Responses-to-Comments

Temporary Public Vehicle Park (Excluding Container Vehicles) for a Period of 5 Years in
'Village Type Development' Zone, Lot 1422 RP (Part) in D.D. 83, Lung Yeuk Tau, Fanling, N. T.

(Application No. A/NE-LYT/824)

Project No. 83015	Rev.
Dwg No. Figure 2	-

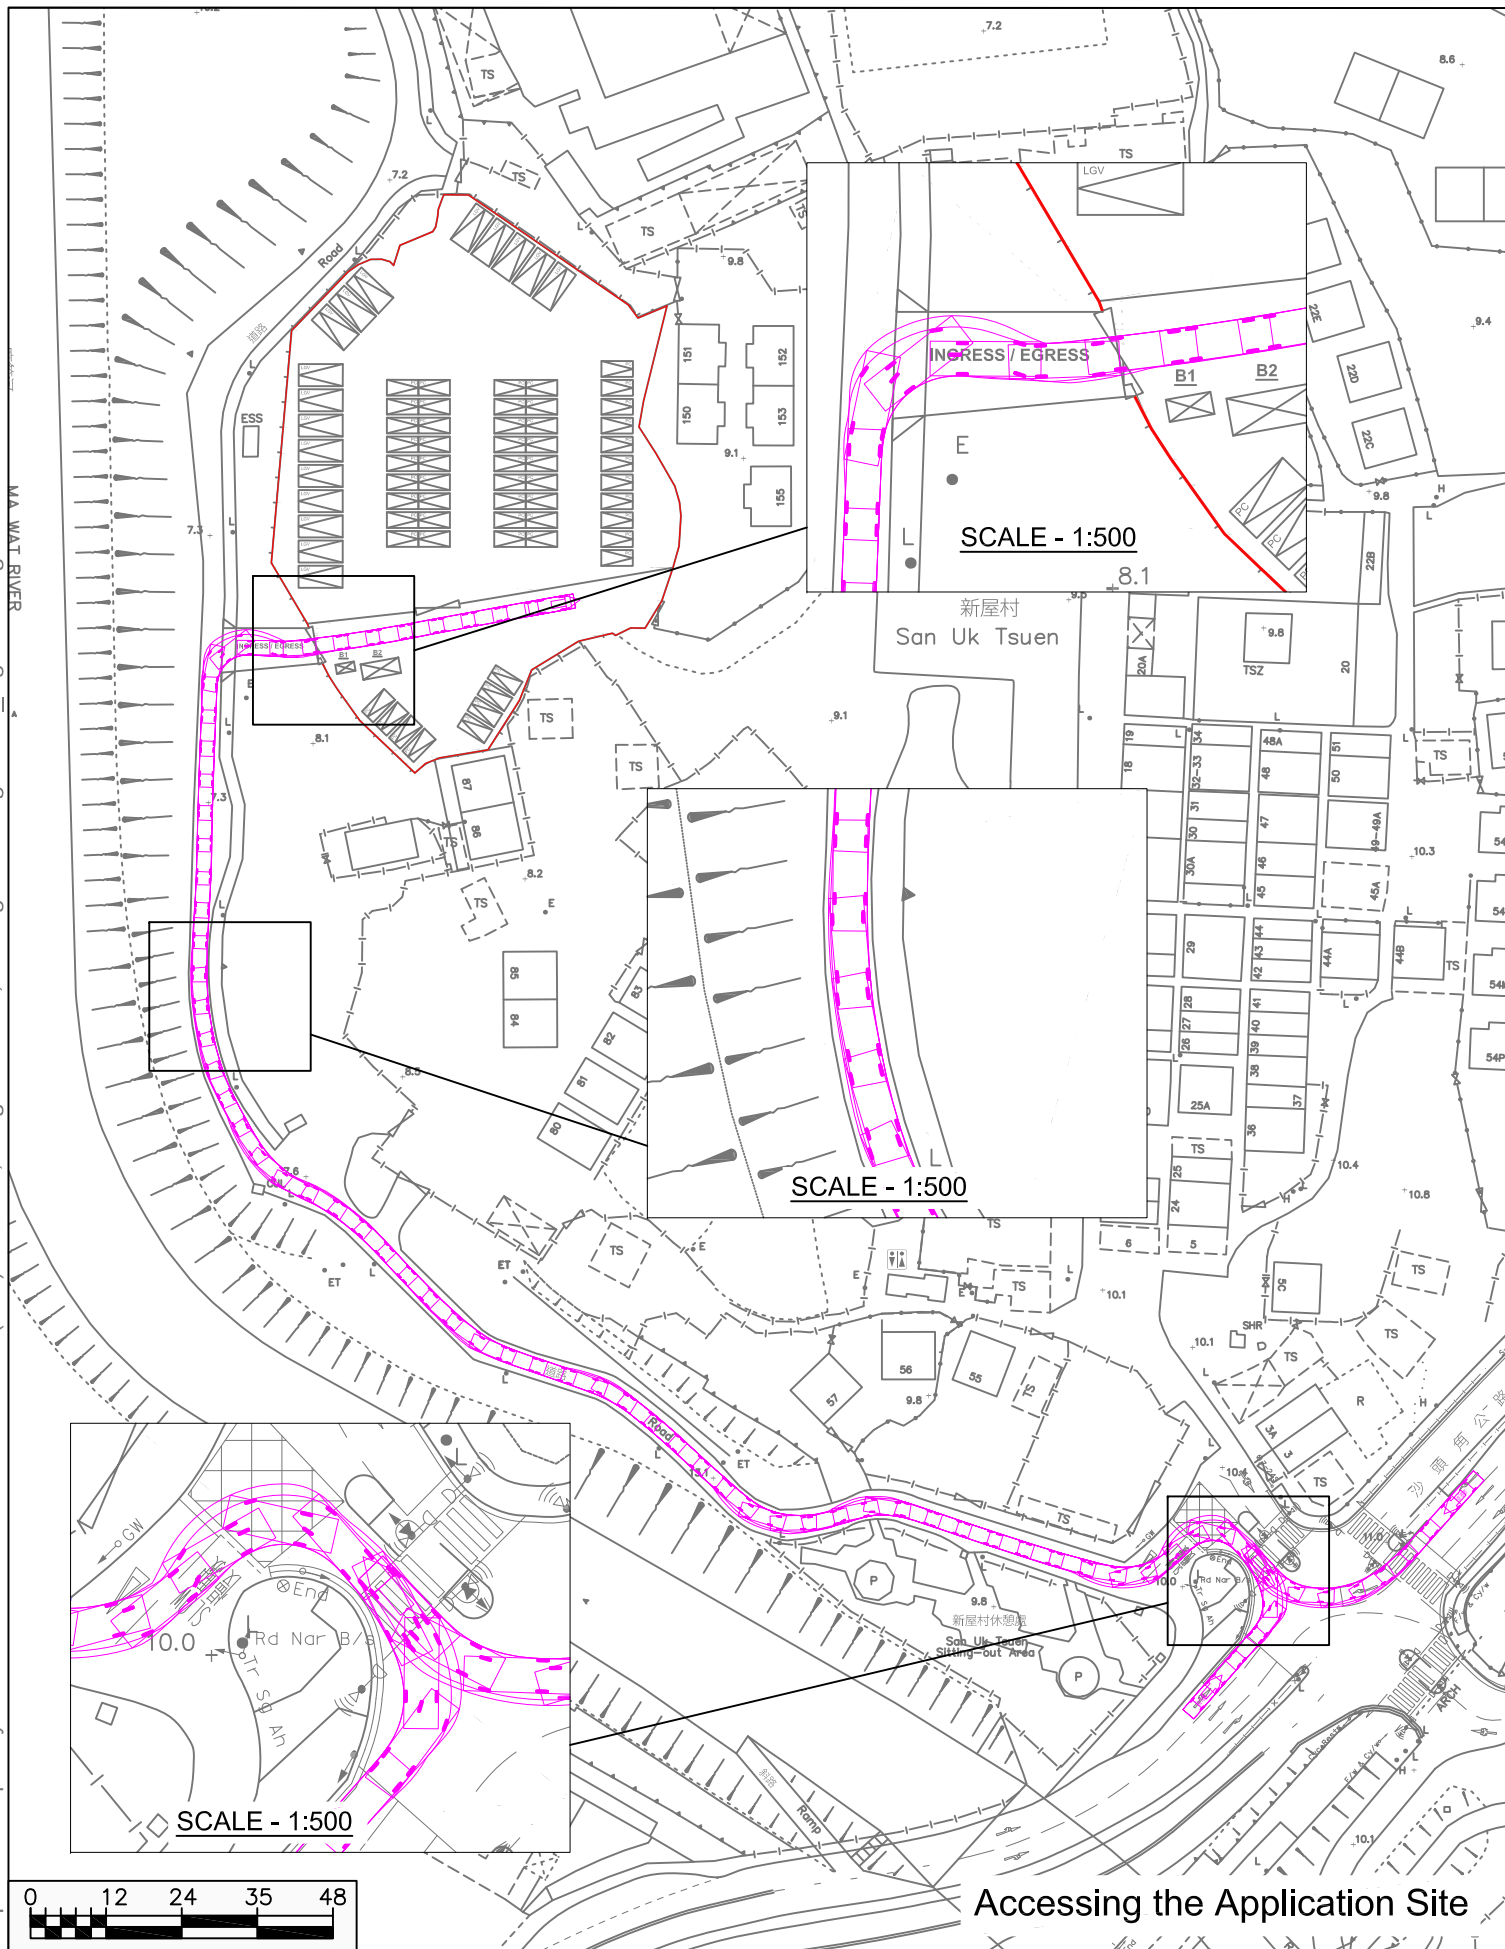
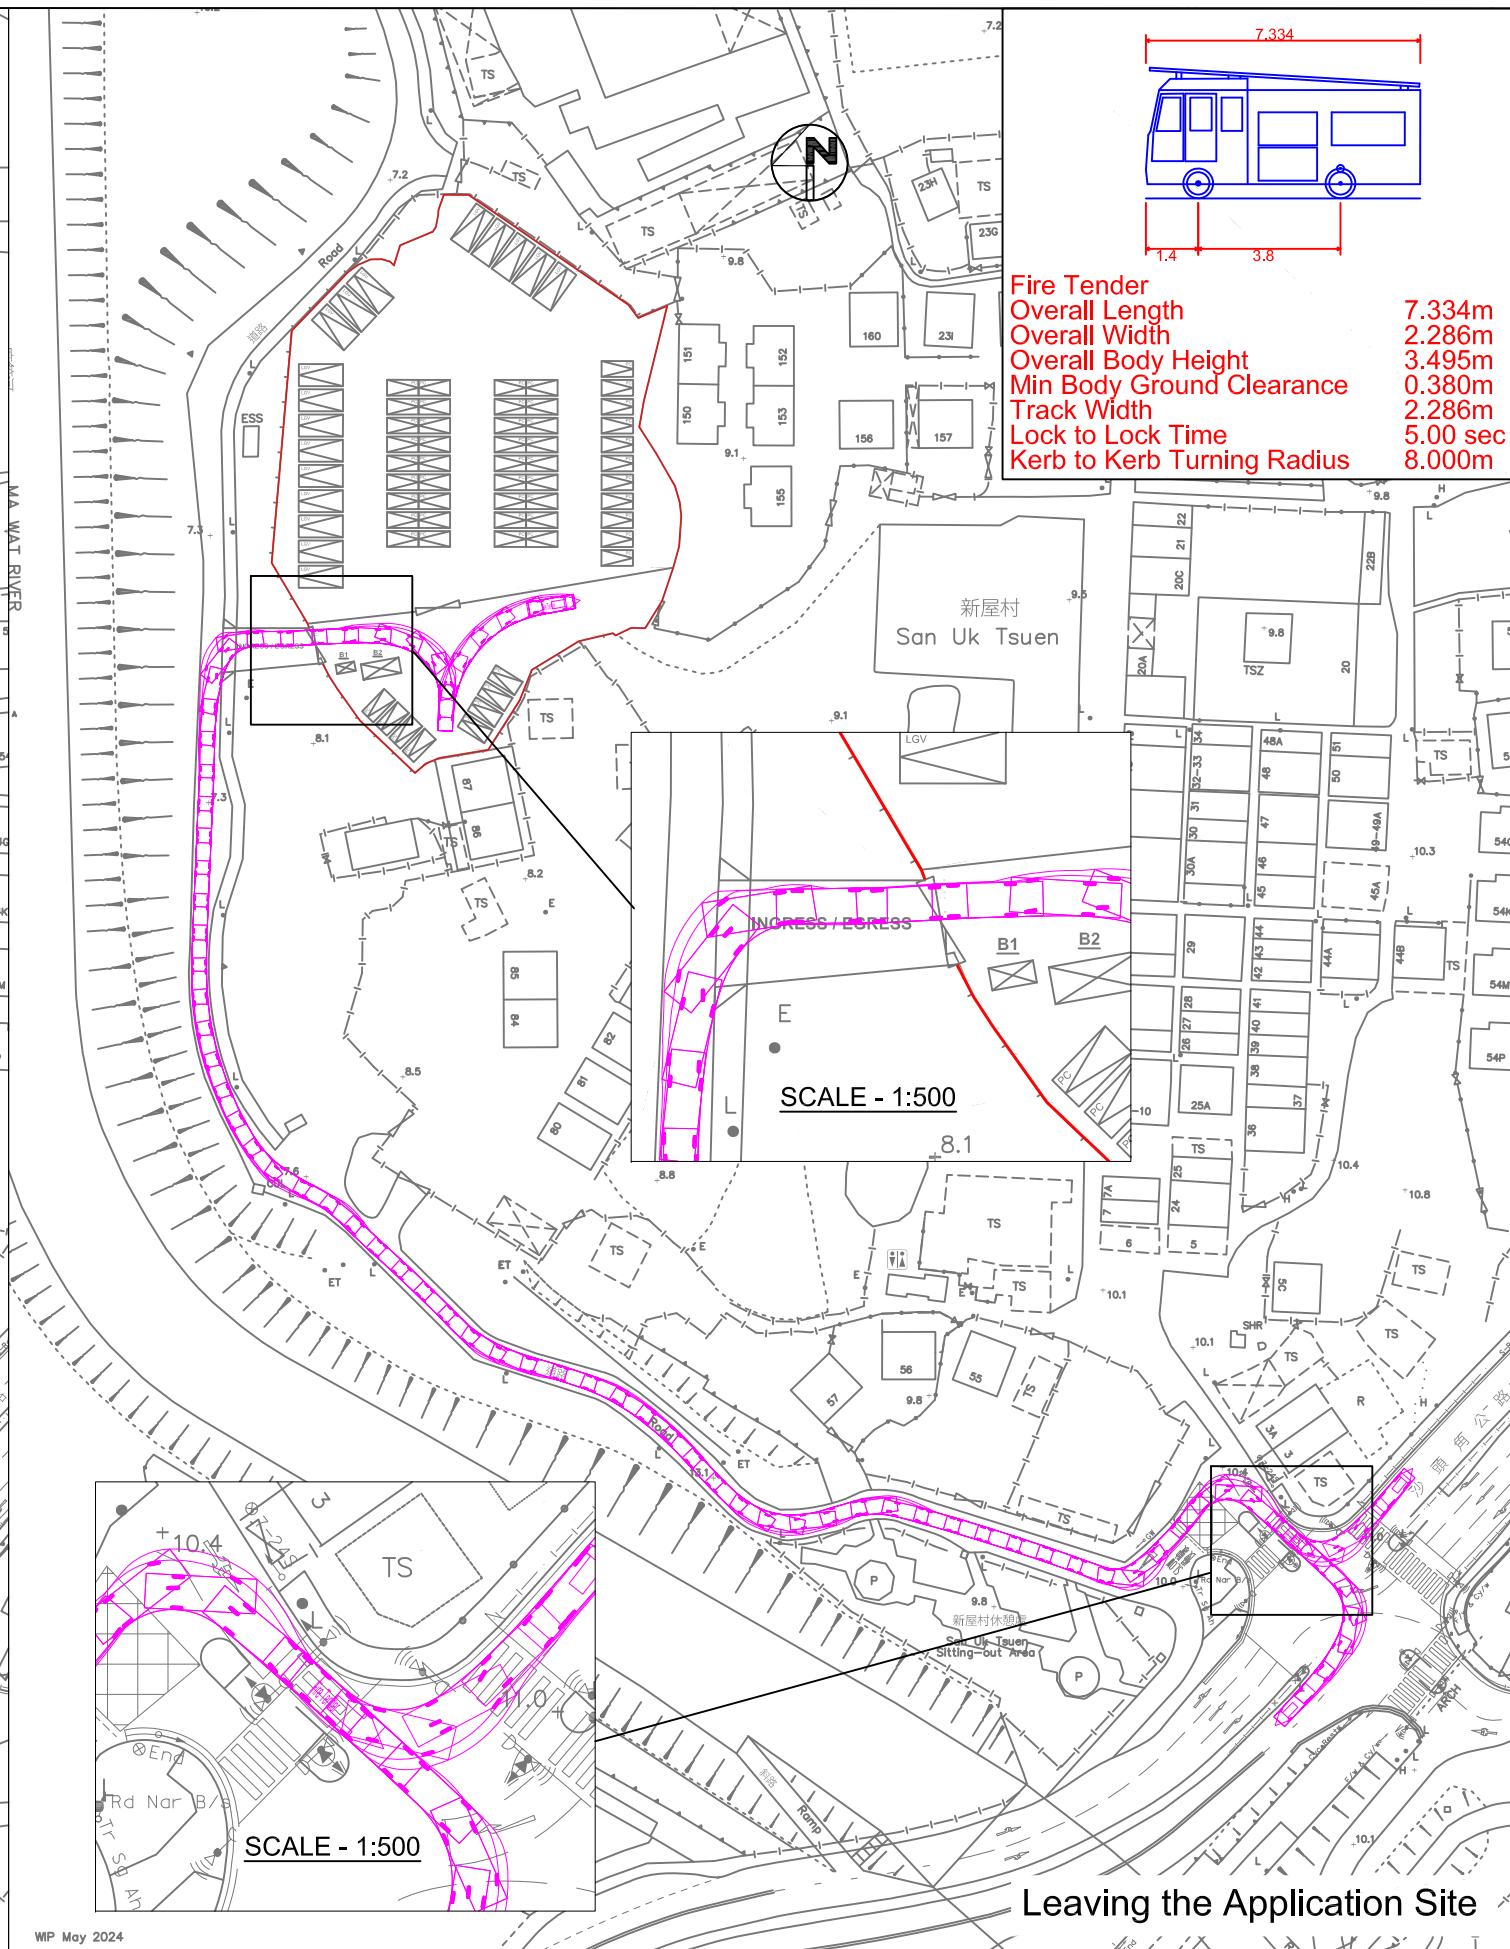
(h)	The applicant shall seek advice from the Fire Services Department or other relevant authorities if any emergency vehicular access is affected.	Noted. The swept path of fire tender is shown in Figure 2 , the fire tender can manage to access and leave the Site. The RtoC will be circulated to the relevant authorities for comments if emergency vehicular access will be affected.

Annex A	
Project No. 83015	Rev.
Dwg No. 0627-SP-Layout	-

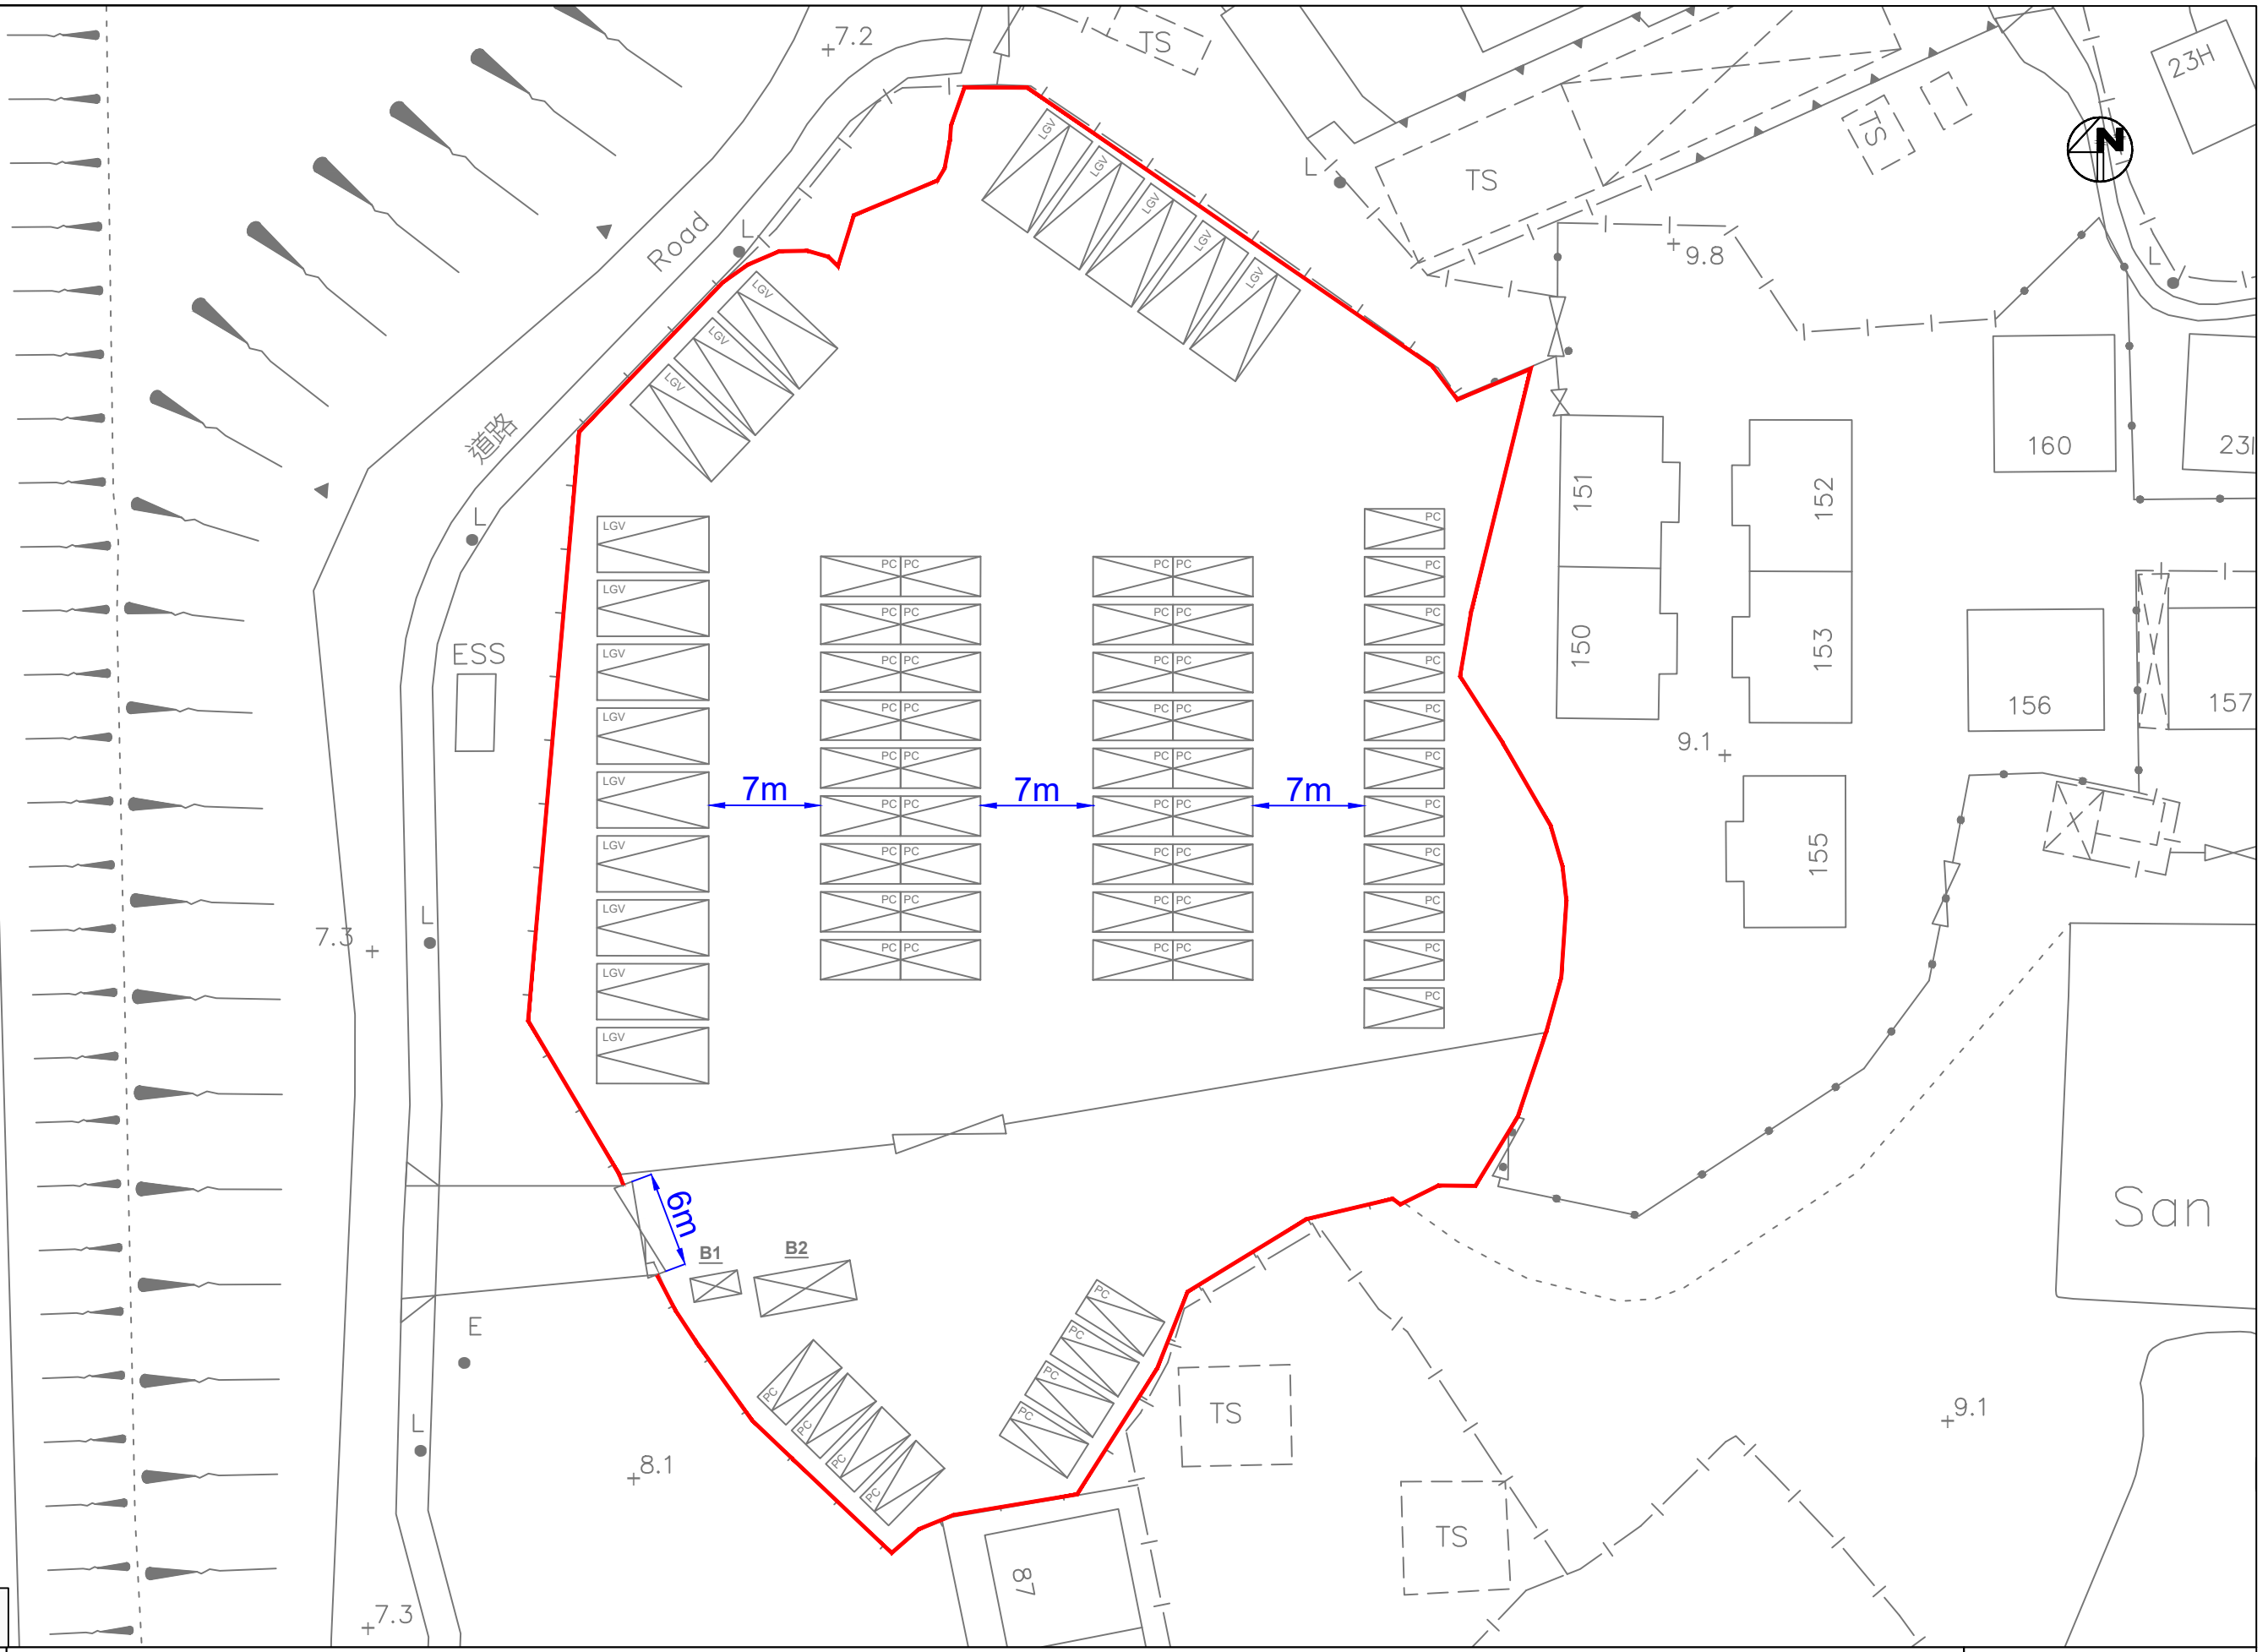
Weekday AM		Weekday PM		In	Out	In	Out	Net Increase of Peak Hour Private Car Trips (Veh./hr)	+1	+1	+1	+1	Peak Hour LGV Trips (Veh./hr)	1	4	1	1	Total additional Peak Hour Trips (One-Way) (Veh./hr)	2	5	2	2
	Weekday AM			Weekday PM																						
	In	Out	In	Out																						
Net Increase of Peak Hour Private Car Trips (Veh./hr)	+1	+1	+1	+1																						
Peak Hour LGV Trips (Veh./hr)	1	4	1	1																						
Total additional Peak Hour Trips (One-Way) (Veh./hr)	2	5	2	2																						
(b)	<p>Please justify whether the village road between the site entrance and Sha Tau Kok Road has sufficient capacity to accommodate the additional vehicular flow from the operation of the proposed temporary public vehicle park;</p>	<p>Based on the traffic survey, the hourly traffic flows of the village road are less than 90 vehicles per hour. With the additional vehicular flows of maximum of 7 (=2+5) vehicles per hour from the Site, the hourly traffic flows of the village road are less than 100 vehicles. Thus, based on TPDM, Volume 2 Chapter 3.11, the village road between the site entrance and Sha Tau Kok Road are capable to cope with the additional vehicular flow from the proposed temporary public vehicle park.</p>																								
(c)	<p>The applicant should advise the width of the vehicular access leading to the site;</p>	<p>The ingress / egress width is about 6m in width while the vehicular access leading to the Site is about 7m in width. The measurements are shown in Figure 1.</p> <p>As shown in Figure 1, the LGV can access to / leave from the Site smoothly.</p>																								
(d)	<p>The applicant shall demonstrate the satisfactory maneuvering of vehicles entering to and exiting from</p>	<p>The swept path assessments are prepared and can be found in Annex A.</p>

the subject site (including the maneuvering from and to Sha Tau Kok Road - Lung Yeuk Tau), preferably using the swept path analysis;	The swept path indicates that the LGV can entering to and exiting from the subject site smoothly, and enough spaces are provided within the Site. Furthermore, the swept path indicates that the LGV could manage to drive through the village road to and from Sha Tau Kok Road.
